August 12, 2011

Mr Weidong Wang, Senior Engineer  
ACRS/TSB, Nuclear Regulatory Commission  
Mailstop 2 E26 TWFN  
Rockville, Maryland 20852

**SUBJECT: Question for ACRS Meeting on August 16th, 2011 (Rev 19 of AP1000 DCD) concerning whether solar radiation on the physical model was accounted for in interpreting experimental data in the "Large Scale Test" that was used to validate WGO THIC, which is used in Rev 19 calculations for predicting heat and mass transfer aspects of the effectiveness of Passive Containment Cooling System in reducing containment pressure.**

Figure 6-4: Large Scale Test Facility

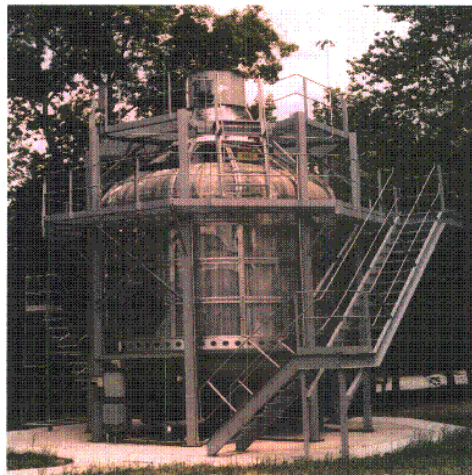
If the above is a photograph of the site on which the test was performed (i.e., if the test was performed outdoors during the day), which I believe it is, then the wetted surface of the Large Scale Test (LST) of the Passive Containment Cooling System (PCS), was in the presence of the sun when the experimental test data was taken. The figure below, which is from an article in an engineering journal (Ref. 3) is applicable to that situation, and the factors depicted in it need to be taken into account when interpreting the test data:

In the LST model, which is a physical model, the baffle/shield building was represented, if at all, using a *transparent* material. **The physical model's being in the presence of sunlight thus aided evaporation in the PCS LST test.**

I have so far not run across any discussion of the fact that the test model of the steel containment shell was located in the sun whereas the actual containment is located within the shield building, largely shaded from sunlight.

The problem is that it appears that in the test situation (PCS LST) against which the computer code WGOthic was compared, the wetted surface was exposed to solar insolation (i.e., radiative heating from sunlight was present), whereas the situation WGOthic is being used to make predictions about is one in which it is not: inside the shield building, which is where the PCS delivers the water film over the steel containment. The interior is largely shielded from sunlight. The Westinghouse presentation at an NRC meeting on 30 June 2011 presented this figure:

Fig. 1. (a) Schematic sketch of, "Flowing water over the roof" system. (b) Overside view of the flowing water system.

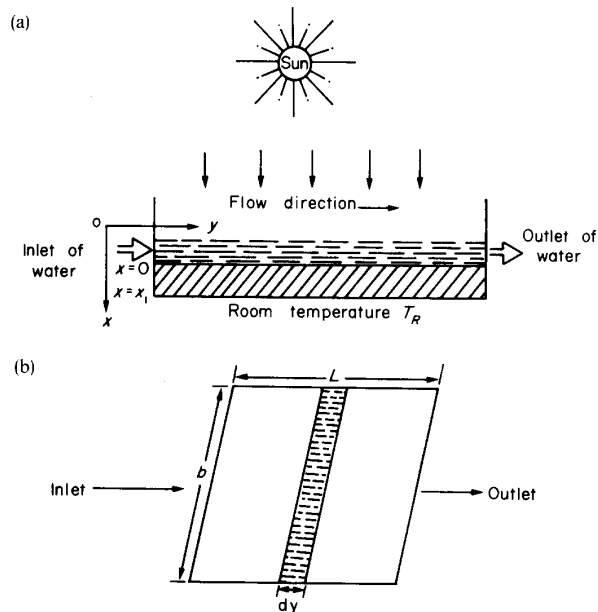
The above figure (Figure 1 of Tiwari 1981) correctly depicts the role of the sun in the **Large Scale Test situation** of the Passive Containment Cooling System (PCS) **LST**, which, it appears, was performed outdoors, in the presence of sunlight.

The symbol for solar radiation in the cited paper (Tiwari 1981) is  $H_s$ , as indicated in the nomenclature list on the first page of the paper.  $H_s$  occurs in the general energy balance equation for figure 1(b) in Tiwari 1981's paper (reproduced above). The general energy balance is equation (2) of the Tiwari 1981 paper; **the energy balance is basic physics and not a matter of controversy or interpretation.**

### **Passive Containment Cooling**

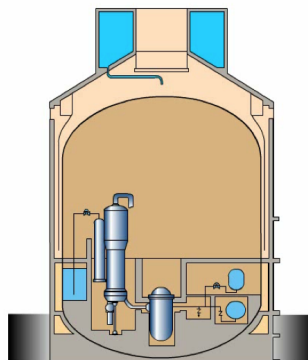
It was also stated that the computer code WGOthic was used in the safety analysis for the AP1000 to predict PCS effectiveness in removing heat from the containment, and thus to predict its effectiveness in reducing containment pressure. Per the docket materials submitted describing the analysis performed in calculating containment pressure for Rev 19 changes, the computer code was validated by comparing the results that WGOthic predicted for the LST test with the results obtained experimentally in the LST test.

Since the LST test was conducted in the presence of sunlight, and the WGOthic model of the PCS performance was validated against it, won't the WGOthic model of the AP600/AP1000 containment response tend to *overestimate* the evaporative losses that will occur when the PCS operates as installed in the AP1000 plant? I ask this because, in the AP1000 plant, as in the AP600 plant, the wetted containment surface is indoors, in the dark, inside the shield building. Since evaporative losses *reduce* containment pressure, doesn't this mean that, unless the effect of the sunlight is quantified and accounted for in some way, using this approach to validate a computer code such as WGOthic results in a computer code that *underestimates* the containment pressure?

Figure 6-3: Small Scale Test Facility

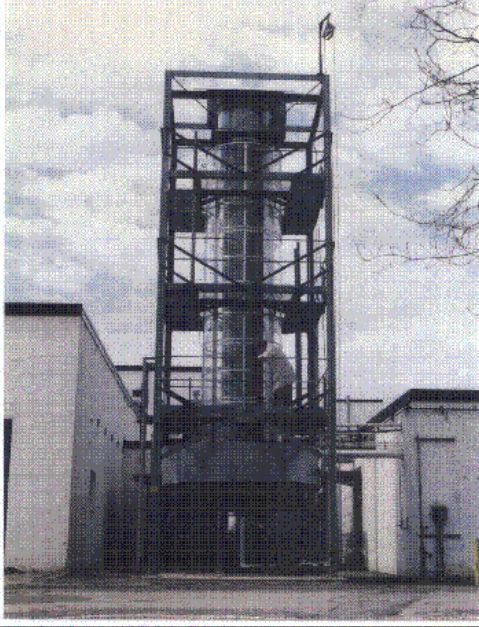
The photograph of the Small Scale Test Facility, also taken from material submitted for rev 19 of the AP1000 DCD, likewise portrays it outdoors, so agreement between the small scale test experiments run on this facility, and the large scale tests cannot be appealed to in order to dismiss the significance of the test being performed outdoors:
